Final Plat Royals Ranch Addition, Phase 4 - ETJ

August 20, 2020

REF.: “Final Plat of the Royals Ranch Addition, Phase 4, to the City of Waco, McLennan County, Texas” - ETJ

Project Number: 20-00021-S-SUBD

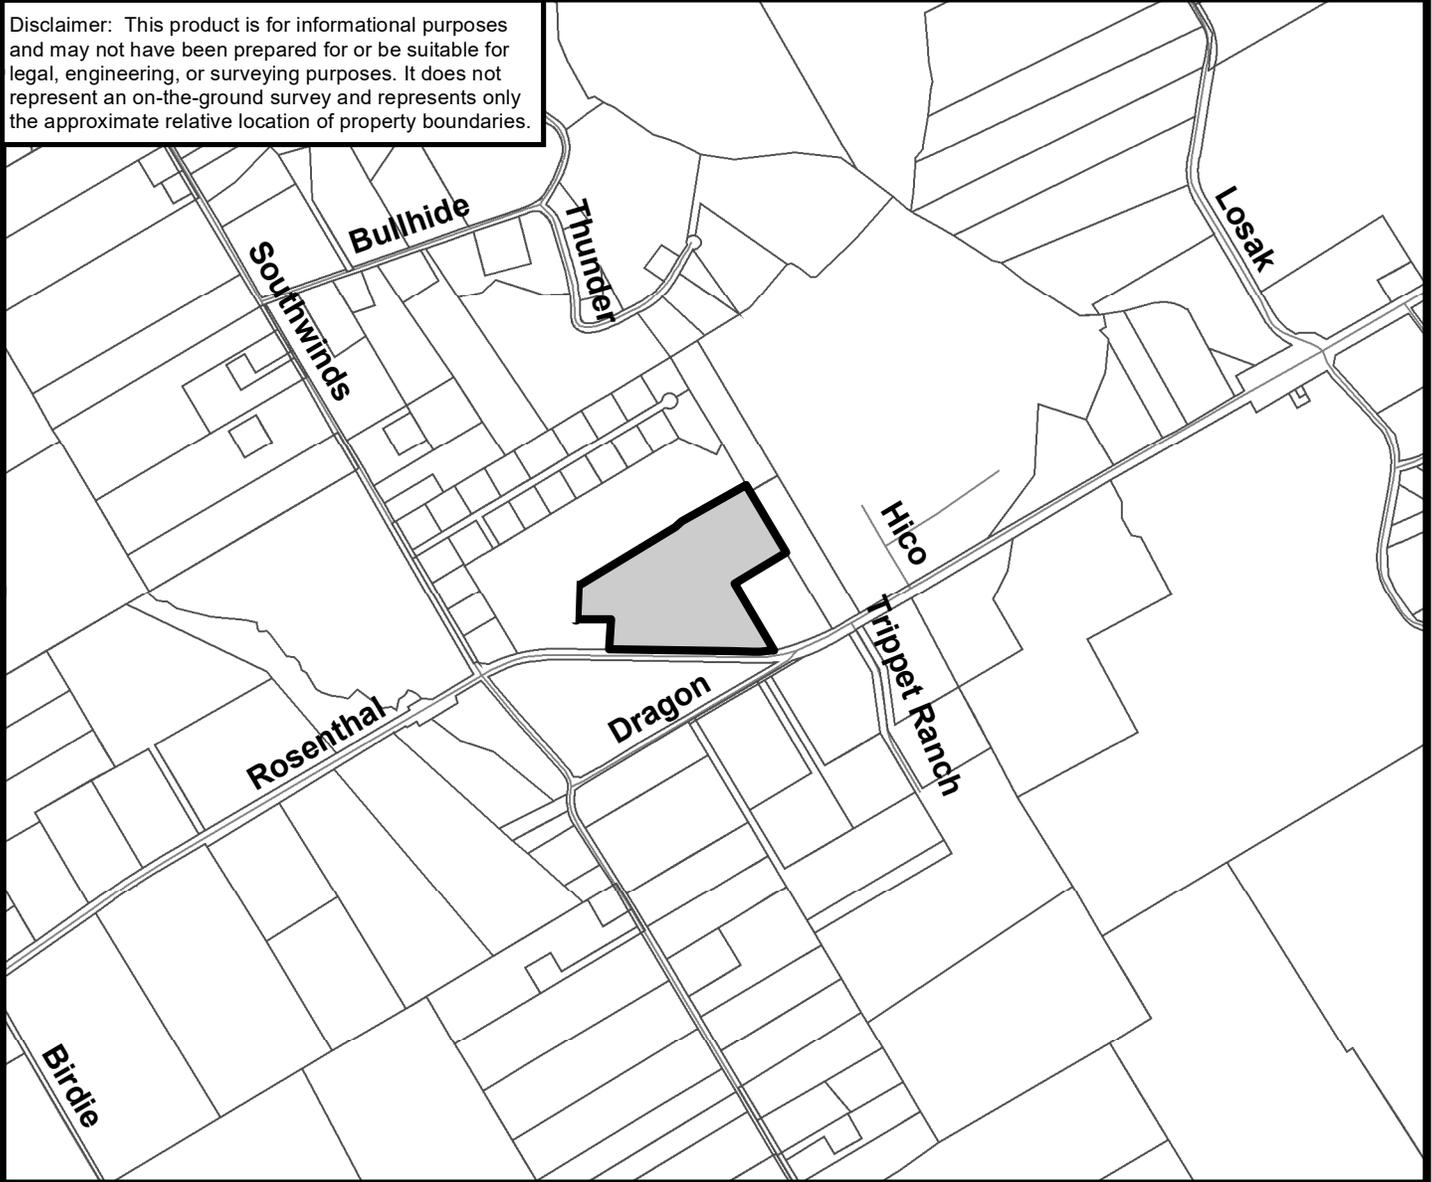
1. The current owners of the property need to sign the dedication. A Notary Public in the appropriate county and state shall notarize the signature. The owners need to provide proof of ownership (i.e. deed) of the property to Planning Services through the CSS Portal and lienholder documentation if applicable.
2. The surveyor needs to sign and seal the plat and set the monuments as shown.
3. Please upload the current “Tax Certificate” from the McLennan County Tax Office stating that all taxes have been paid for the property. This subdivision plat request may not be recorded at the County Clerk's Office

4. Construction for drainage improvements must be in accordance with the approved construction plans for the additions. Either the construction of the improvements must be completed and then approved by the City of Waco, or a performance guarantee submitted and approved before the plat can be filed for record. The performance guarantee and the required $\frac{3}{4}$ of 1 percent review and inspection fee can be based upon the engineer's estimated construction cost.
5. Please add street names to the final plat
6. Ordinance App. B Section 5.205.M "Traffic Control Devices". Street name signs and appropriate traffic control (i.e. Stop signs) are to be installed at time of development at the cost of the developer.
